## ASSESSMENT REPORT

### Section 4.55(1A) Modification

#### Sigma Pharmaceutical Warehouse and Distribution Facility (SSD 7719 MOD 1)

**Figure 4: Proposed Warehouse Plan (Key Changes Highlighted in Red)**

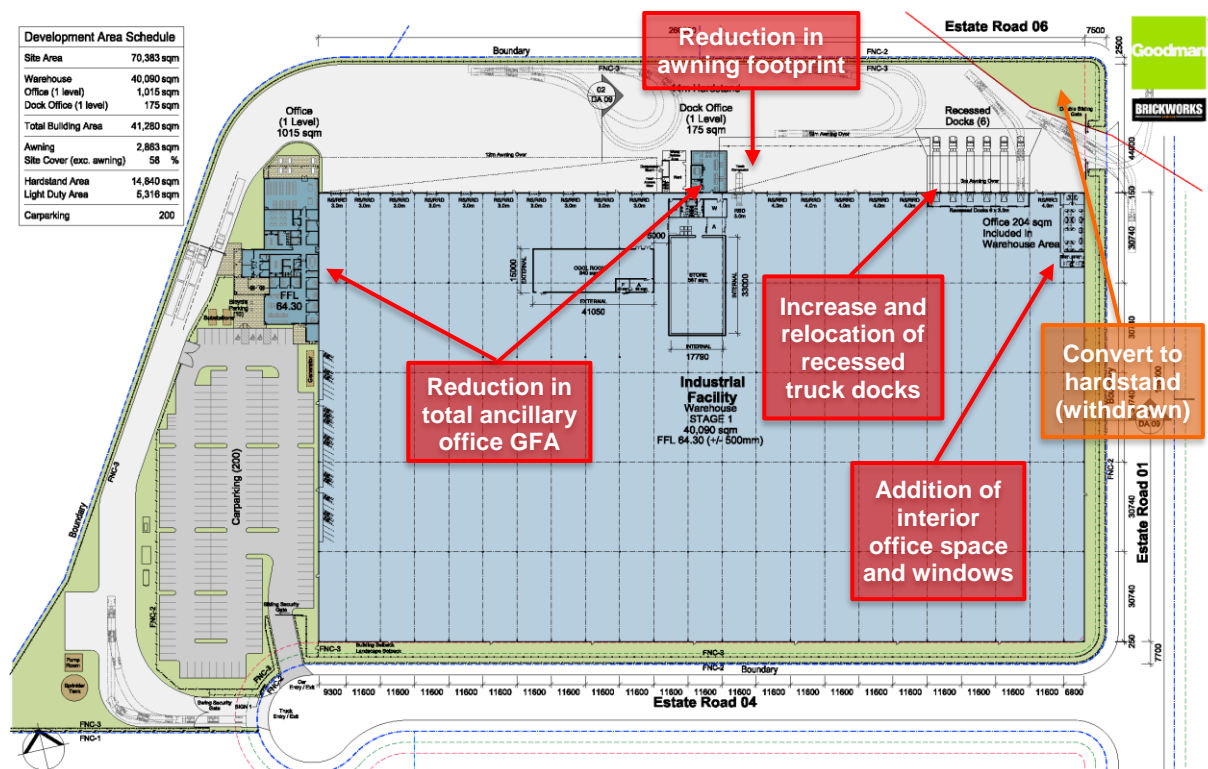
Manoeuvrability	<ul style="list-style-type: none"> <li>The proposed modification involves relocating the recessed truck docks closer to north-east corner of the site (see <b>Figure 4</b>), which has the potential to impact upon site manoeuvrability.</li> <li>The Department raised concerns regarding site manoeuvrability and noted the recessed truck docks would be closer to the landscaped area, having the potential to impede the ability of trucks accessing these docks.</li> <li>The recessed truck docks would also be closer to the emergency access, having the potential to impede emergency vehicles access to the site.</li> <li>The Applicant provided updated swept path diagrams at the Department's request.</li> <li>The Department's assessment concludes the updated swept path diagrams demonstrate the longest vehicle could safely manoeuvre around the site and emergency vehicle access would not be impeded.</li> <li>The existing conditions of consent require the Applicant to ensure the swept path of the longest vehicle utilising the site is in accordance with AUSTROADS guidelines.</li> <li>The Department considers the existing conditions of consent can suitably manage site manoeuvrability.</li> </ul>	Manage via existing conditions.

Figure 5: Proposed Signage Plan (Changes Highlighted in Red)

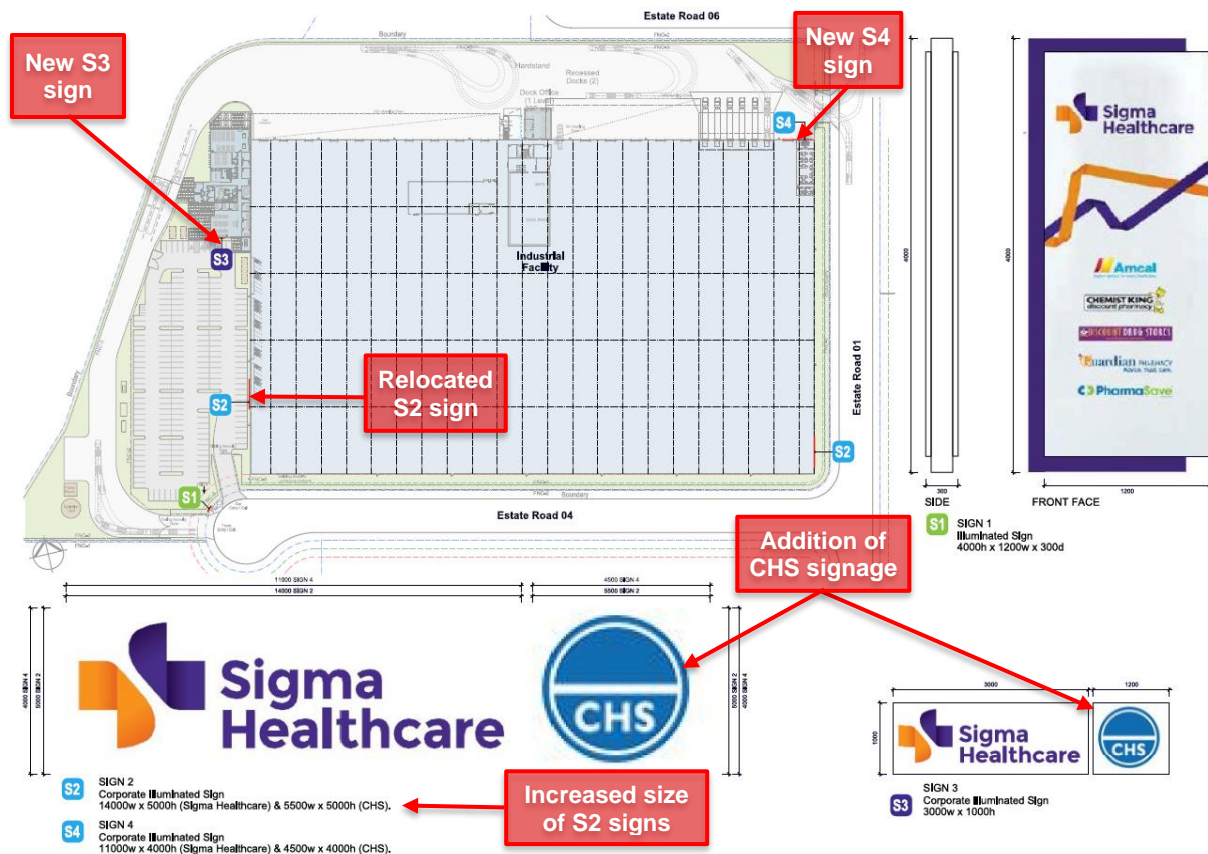
Issue	Assessment	Recommendation
Signage	<ul style="list-style-type: none"> <li>• The proposed modification increases the overall amount of signage, which has the potential to result in visual impact due to its size, content and illumination.</li> <li>• The proposed signage for the warehouse is depicted in <b>Figure 5</b>.</li> <li>• The Department undertook an assessment of the proposed signage against the criteria of State Environmental Planning Policy No. 64 – Advertising and Signage (SEPP 64), which is summarised in <b>Appendix D</b>.</li> <li>• The Department is generally satisfied the proposed signage would be consistent with SEPP 64.</li> <li>• However, the Department was concerned the proposed signage on the western façade of the development. This signage is illuminated and oriented towards the Ropes Creek riparian corridor, having the potential to impact upon fauna.</li> <li>• In response to the Department's concern, the Applicant proposed to illuminate this signage during certain hours.</li> <li>• The Department agrees that restricting the illumination of the western facing signage to certain hours would minimise the potential impacts to the riparian corridor.</li> <li>• The Department notes the neighbouring Toyota facility (SSD 7663) includes a 5.8 m high by 20.8 m wide illuminated business identification warehouse sign, similar in size to the largest sign for the proposed modification.</li> <li>• The Department considers the proposed signage also meets the requirements of the underlying Concept Proposal (SSD 6917), which specifies that a maximum of one illuminated sign is permitted on each warehouse elevation. Illuminated signs must also be oriented away from residential receivers.</li> </ul>	<ul style="list-style-type: none"> <li>• Update Appendix A of the consent to include the updated signage plan.</li> <li>• Require the Applicant to restrict illumination of the western facing signs to daylight hours.</li> </ul>

Issue	Assessment	Recommendation
	<ul style="list-style-type: none"> <li>The Department's assessment concludes the proposed signage would provide adequate business identification and wayfinding for customers and other road users.</li> <li>The Department considers the revised signage plan meets the requirements of the Concept Proposal (SSD 6917) and the assessment requirements of SEPP 64.</li> <li>The Department recommends the conditions be modified to incorporate the revised signage plan and to include restrictions on the signage illumination to daylight hours.</li> </ul>	
Visual	<ul style="list-style-type: none"> <li>The proposed modification would result in changes to the warehouse built form and consequently its presentation to the street.</li> <li>The proposed site plan is depicted in <b>Figure 4</b>.</li> <li>The modification application includes revised warehouse and office elevations, prepared by SBA Architects. The modification application seeks to: <ul style="list-style-type: none"> <li>- amend the awnings along the northern warehouse façade</li> <li>- relocate and increase the number of recessed truck docks</li> <li>- add windows on the north-east corner of the warehouse</li> <li>- amend the ancillary office layout and reduce to one-storey.</li> </ul> </li> <li>The Applicant undertook an assessment of the proposed modification against the development controls of the Concept Proposal (Condition B10 of SSD 6917). The assessment concluded the character, height and scale of the amended warehouse would be consistent with the development controls.</li> <li>The Department considers the warehouse façade would be visible by road users and customers, but not by local residents. The development is consistent with the local character as it is located within an industrial precinct.</li> <li>The Department's assessment concludes the proposed warehouse amendments would not result in additional impacts beyond what has been assessed as part of the original application (SSD 7719) and the Concept Proposal (SSD 6917).</li> <li>The Department recommends the approved plans within the consent be updated to reflect the proposed modification.</li> </ul>	Update Appendix A of the consent to include the relevant updated plans.
